DEVELOPMENT APPLICATION ASSESSMENT REPORT

Application Number:	DA2024/1153
----------------------------	-------------

Responsible Officer:	Lachlan Rose
Land to be developed (Address):	Lot B DP 925573, 120 Crown Road QUEENSCLIFF NSW 2096
Proposed Development:	Alterations and additions to a dwelling house including a carport
Zoning:	Warringah LEP2011 - Land zoned R2 Low Density Residential
Development Permissible:	Yes
Existing Use Rights:	No
Consent Authority:	Northern Beaches Council
Land and Environment Court Action:	No
Applicant:	Rebecca Grattan

Figure 1: Front Fence

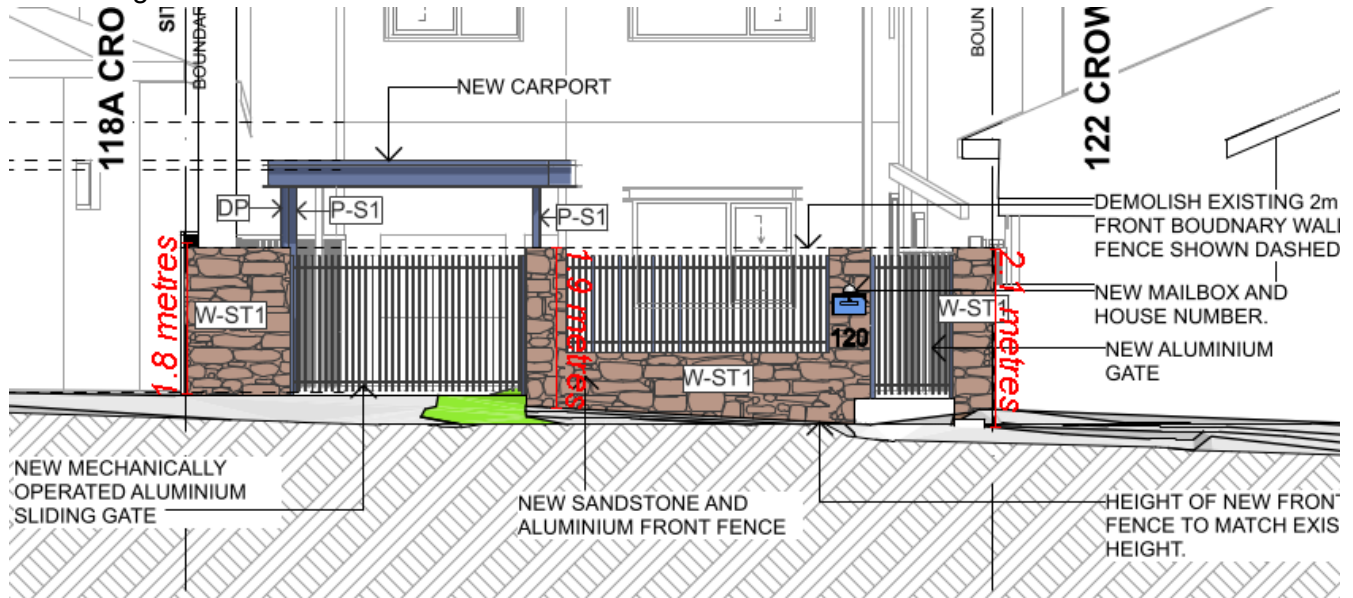
The proposal includes a front fence that varies from 1.8m to 2.1m high with a design comprised of sandstone and aluminium vertical slats. The front fence includes the aluminum slatted front mechanical carport gate and access gate. The proposed fence is to replace the existing 2m front boundary fence with a similar design.

It is acknowledged that there are nearby examples of front fences that vary in heights from 1.8m and/or above. There is a current approval for a front fence of 1.8m to 2.1m at 153 Crown Road, located directly opposite to the subject site. To achieve consistency with fencing within the immediate streetscape, the front fence has been designed to include transparent/open aluminum slatting to avoid a walled in streetscape. It should be noted that the proposed fence has been shown on the plans to be

constructed at the same height as the existing front fence. As there are multiple front fences along Crown Road which are located at 1.8m and above, the proposed fence will complement the existing streetscape and not result in a change in height from the existing front fence.

The subject front fence height is acceptable within the streetscape and the proposed slatted design will avoid a 'walled in' streetscape. The subject site includes a hedge located behind the proposed front fence which is retained on the plans and in conjunction with the aluminum panels, the proposal will avoid a 'walled in' streetscape.
